SUBJECT **SUBSTITUTION OF SPOTMATIC CAMERA AMMETER**

The SP series Ammeter is now no longer available, we recommend the use of the K1000 ammeter for the substitution.

fig.1

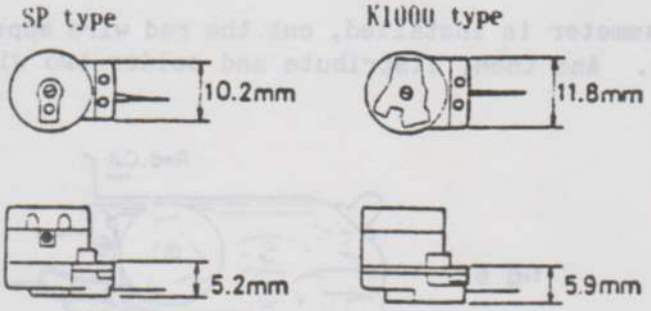
But SP and K1000 type ammeters are physically different as shown in Fig. 1.

fig.2

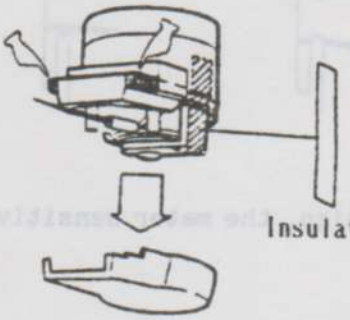
1. Cut both ends of the plastic body as indicated in Fig. 2 by cutter-knife to make the width (10.9mm) --- refer to Fig. 3.
   Be careful not to allow plastic pieces to fall into ammeter mechanism.
2. Remove the bottom cover. It is quite difficult to install K1000 meter with bottom cover in place.
3. Put an insulation tape to the position, as shown in Fig. 2, to prevent the ammeter from shorting out with the body ground.

fig.6

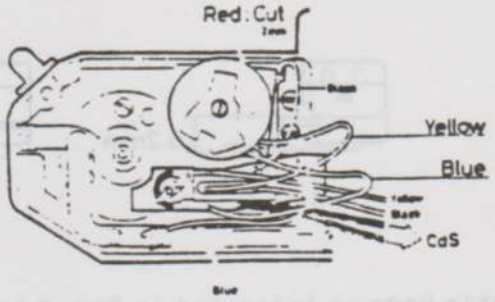
WIRING
After the ammeter is installed, cut the red wire approximately 2mm away from the meter body. And then, distribute and solder two wires as shown in Fig.6.
